Access Compliance Report

Public Rights-of-Way

Intersection ID: 49925	Main Street: PAXTON_RUN_RD	Cross Street: CAMPBELL_HALL_CT	Location: NW
ADA ID: 13C9FCC79A02	Ramp Type: Perp	Initial Pass/Fail: Fail	Overall Compliance: No
Severity Score: 25			
Codes/Mitigation Info/Possible Solution		Field Measurements/Component Compliance

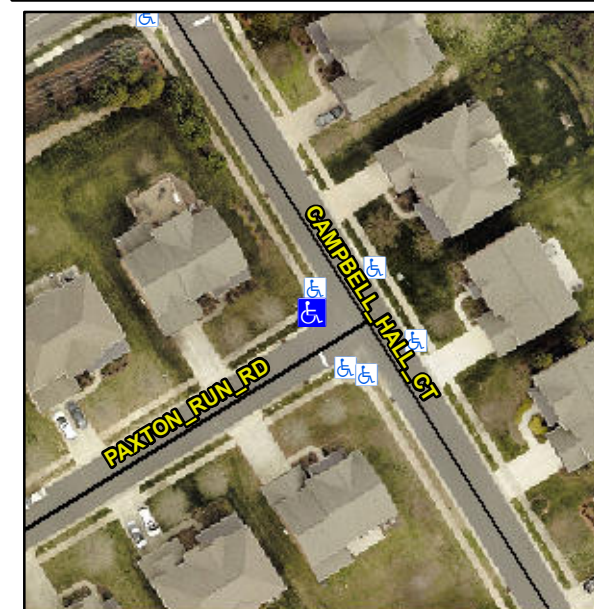
Not Found, R304.2.2

Compliance	Description	Data	Compliance	Description	Data
N/A	Ramp Length (in)	45.0	No	Ramp Slope (%)	14.7
Yes	Ramp Width (in)	48.0	Yes	Ramp XSlope (%)	0.5
N/A	Flare Type LT	N/A	N/A	Flare Type RT	N/A
N/A	Flare Slope LT (%)	N/A	N/A	Flare Slope RT (%)	N/A
N/A	Flare Traversable LT?	N/A	N/A	Flare Traversable RT?	N/A
N/A	Landing Length (in)	N/A	N/A	DWS Provided?	N/A
N/A	Landing Width (in)	N/A	N/A	DWS Contrast?	N/A
N/A	Landing Slope (%)	N/A	N/A	DWS Length (in)	N/A
N/A	Landing X Slope (%)	N/A	N/A	DWS Full Width?	N/A
N/A	Landing Curb? (Y/N)	N/A	N/A	DWS Offset (in)	N/A
N/A	Shared Landing?	N/A			
N/A	Gutter Ponding?	N/A	N/A	Gutter Slope (%)	N/A
N/A	Gutter Lip Ht (in)	N/A	N/A	Gutter X Slope (%)	N/A
N/A	Painted X Walk1?	No	N/A	Painted X Walk2?	N/A
	X Walk 1 Direction	To SE		X Walk 2 Direction	N/A
N/A	X Walk 1 Width (in)	N/A	N/A	X Walk 2 Width (in)	N/A
	X Walk 1 Slope (%)	2.0		X Walk 2 Slope (%)	N/A
	X Walk 1 X Slope (%)	2.0		X Walk 2 X Slope (%)	N/A

Remove & Replace Entire Ramp.
